ARCHITECTURAL DRAWINGS

60 - 80 OXFORD STREET + 2A JAMES ST
WOOLLAHRA, NSW, 2025

SCHEDULE OF CHANGES
DA607/21

REVISION G - S34 AMENDMENTS

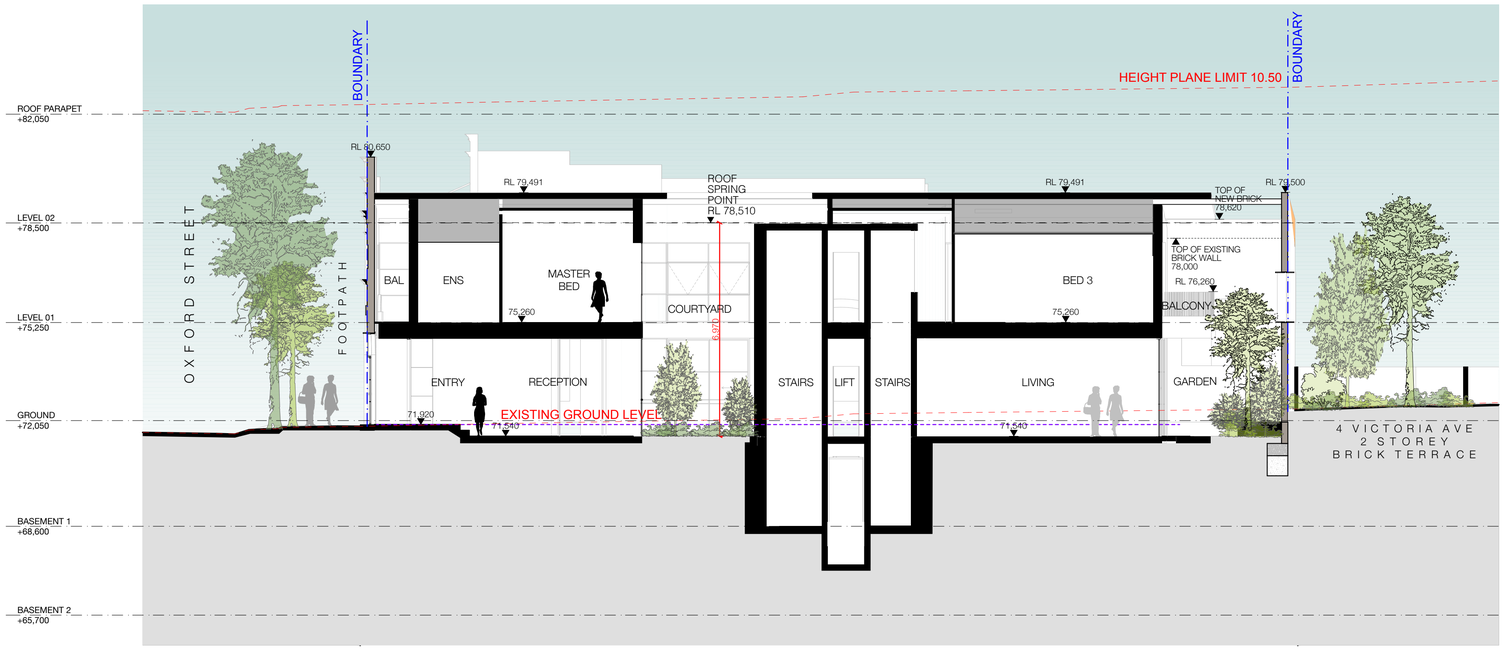
1) #80 INTERNAL LAYOUT AMENDED, GFA INCREASED
2) FLOOR LEVELS AMENDED
3) NEW BRICK ADDED TO TOP OF #80 BRICK EXTERNAL WALLS

1 - BASEMENT 2 1:400

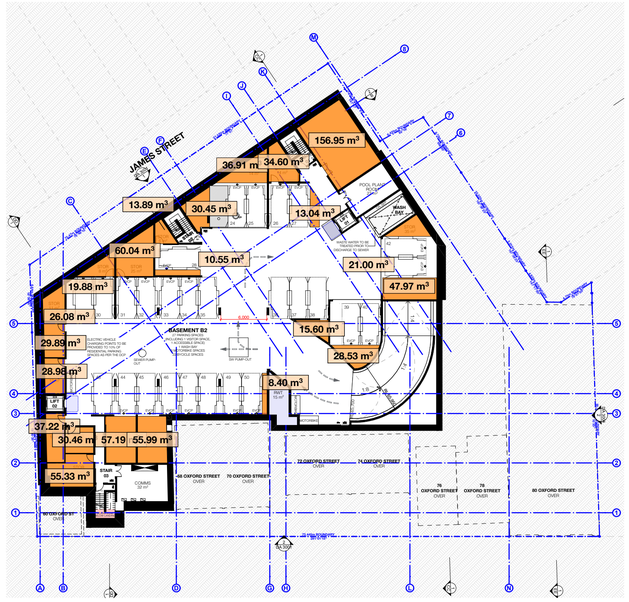
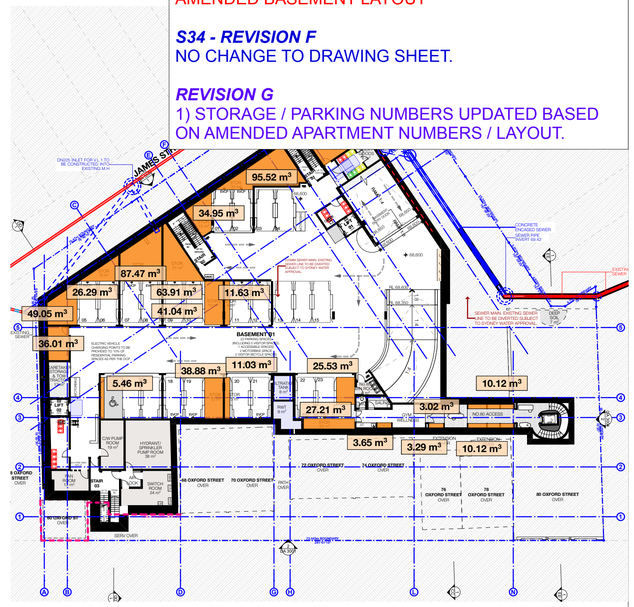
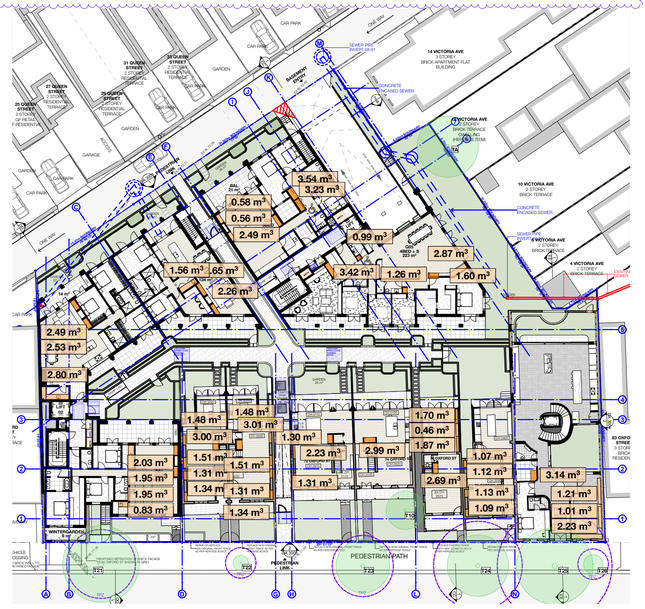
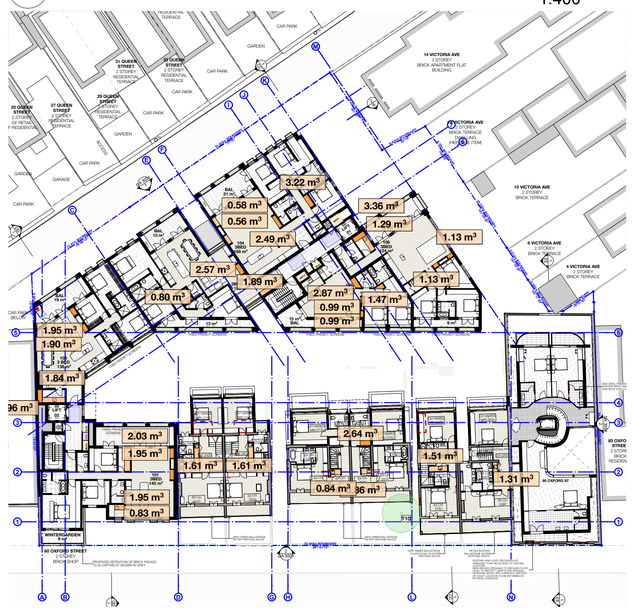
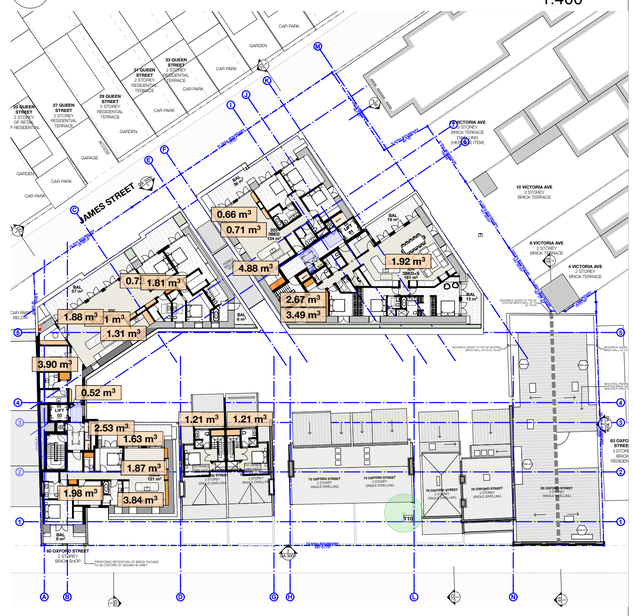
1) PARKING NUMBERS UPDATED TO BE COMPLIANT BASED ON AMENDED BEDROOM MIX
2) STORAGE NUMBERS UPDATED BASED ON AMENDED BASEMENT LAYOUT

3 / - GROUND - BUILT AREA 1:200

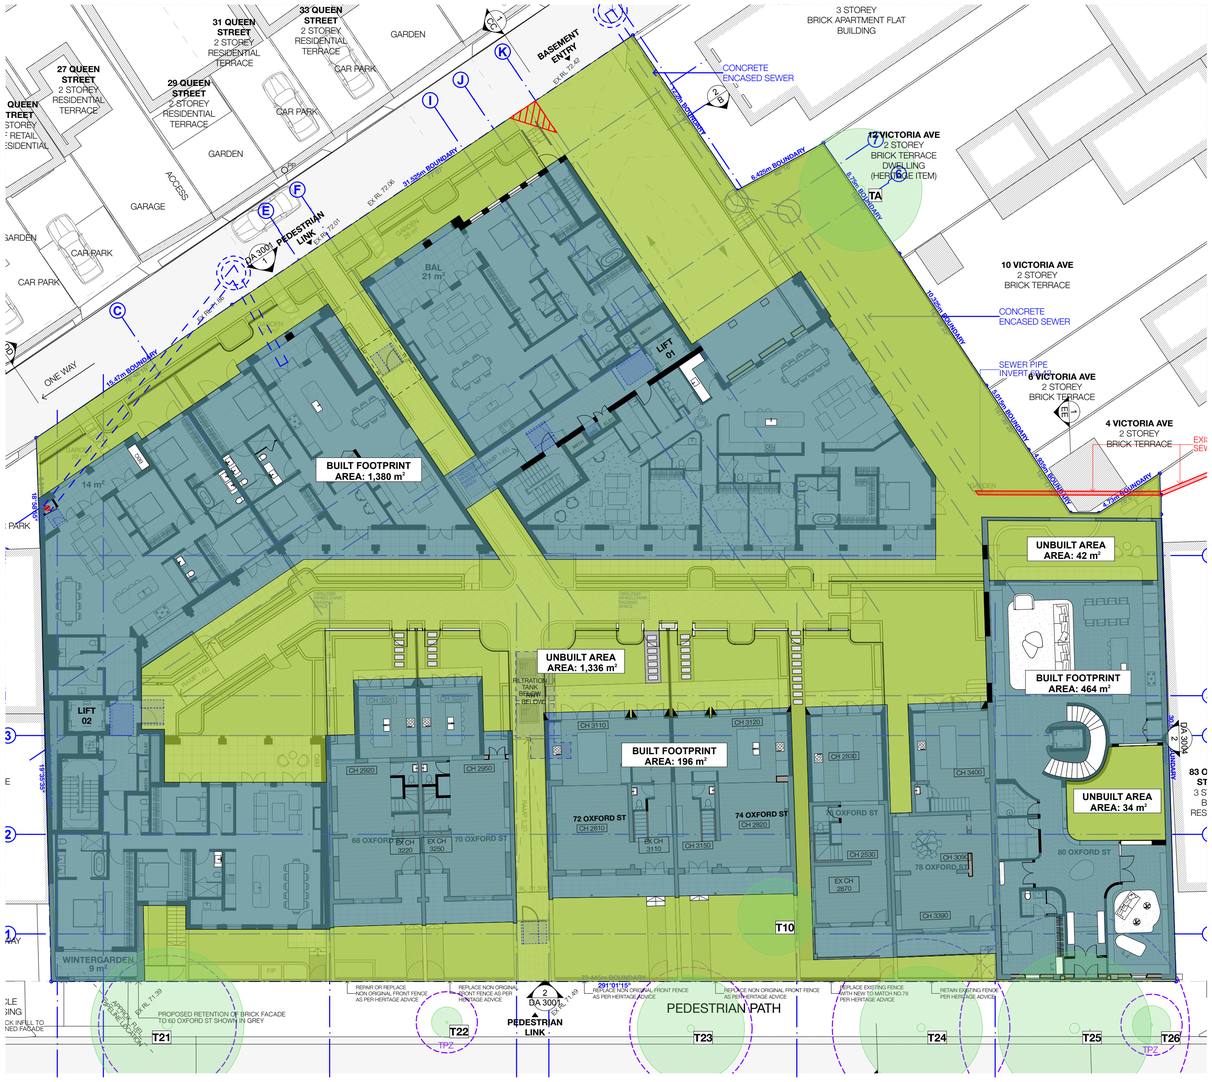
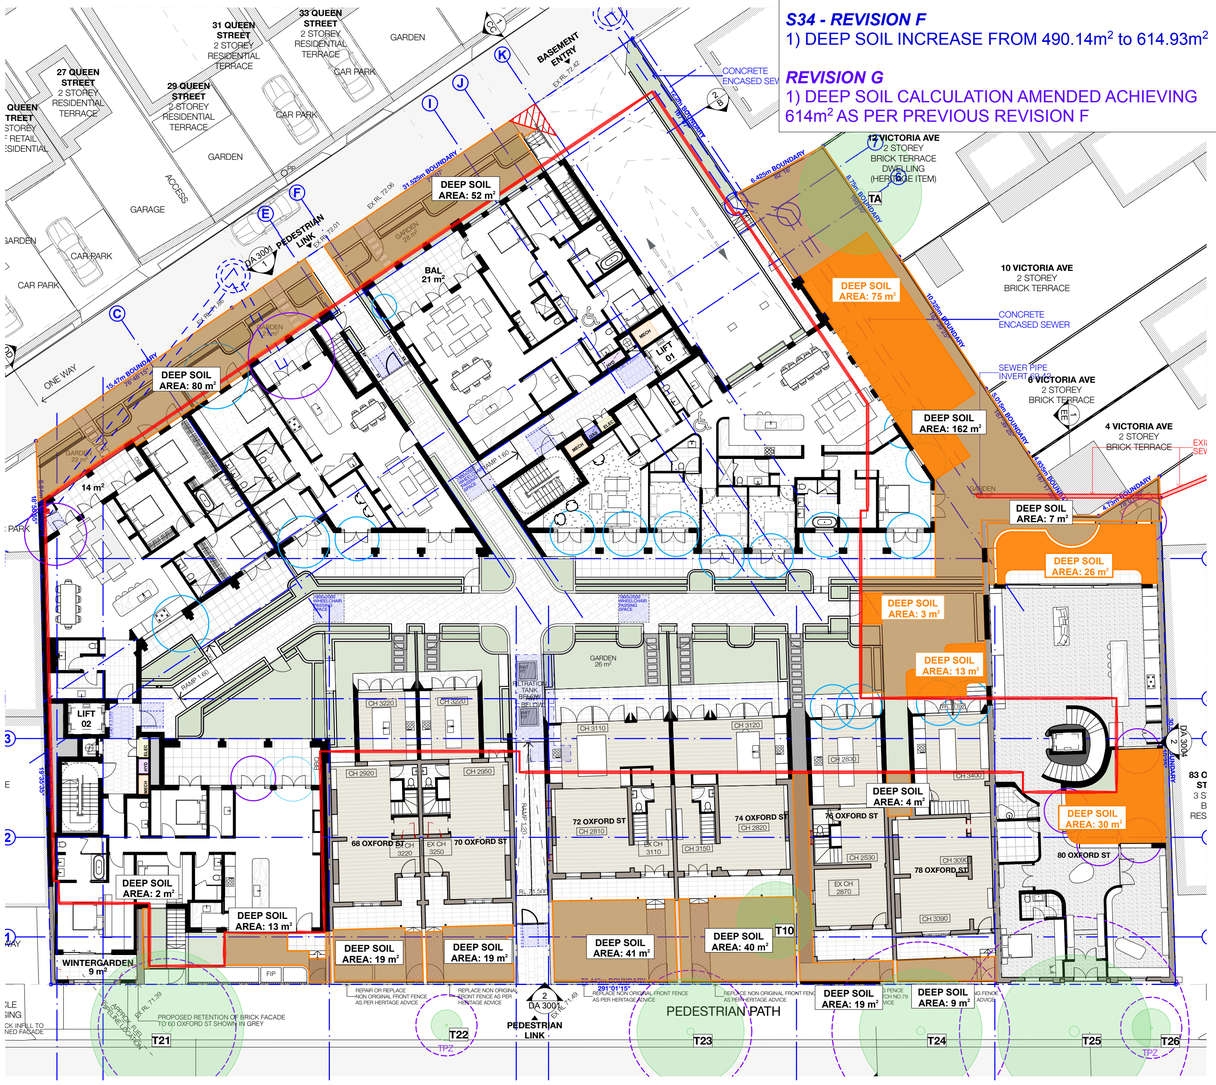
1) BUILT AREA INCREASED TO 59% FROM 57%, UNBUILT AREA REDUCED FROM 43% TO 41%
2) DEEP SOIL REDUCED FROM 693m² to 490.14m²

1 - BASEMENT 1 - WASTE MANAGEMENT 1:200

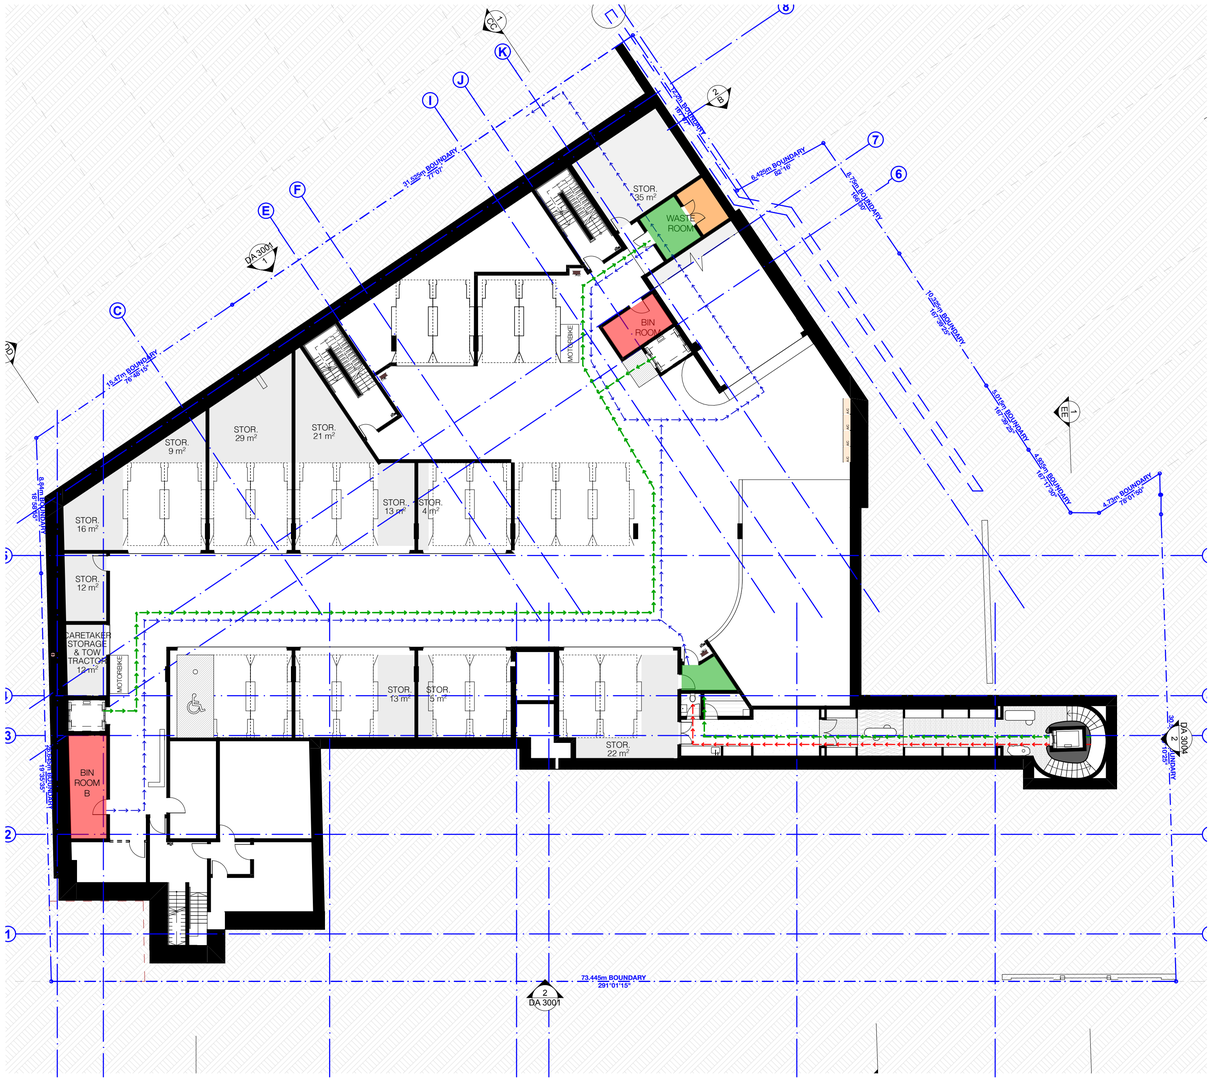
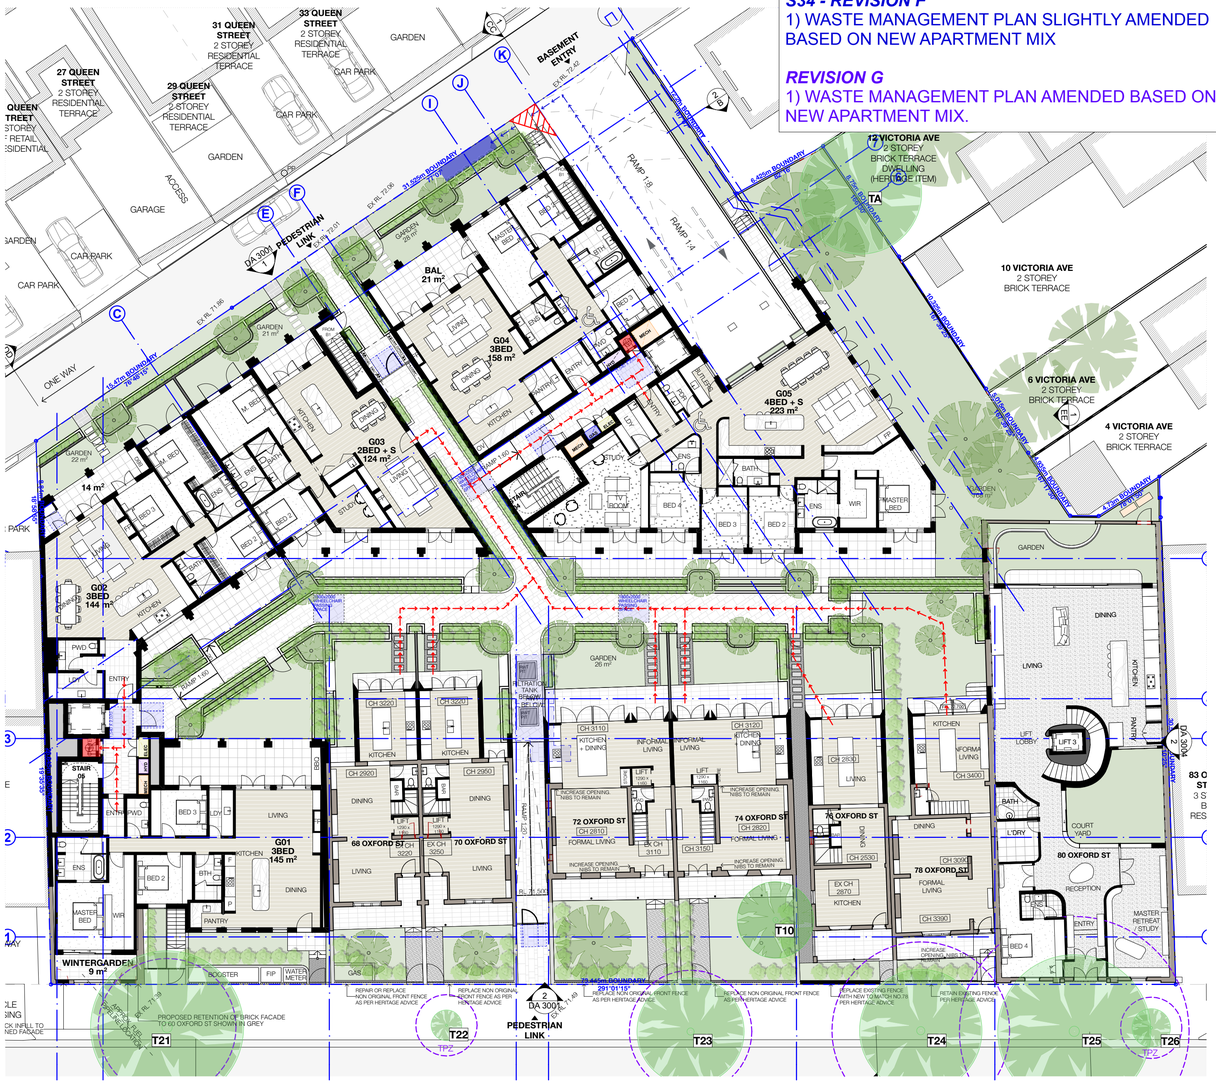
1) WASTE MANAGEMENT PLAN AMENDED TO FIT ADJUSTED BASEMENT LAYOUT
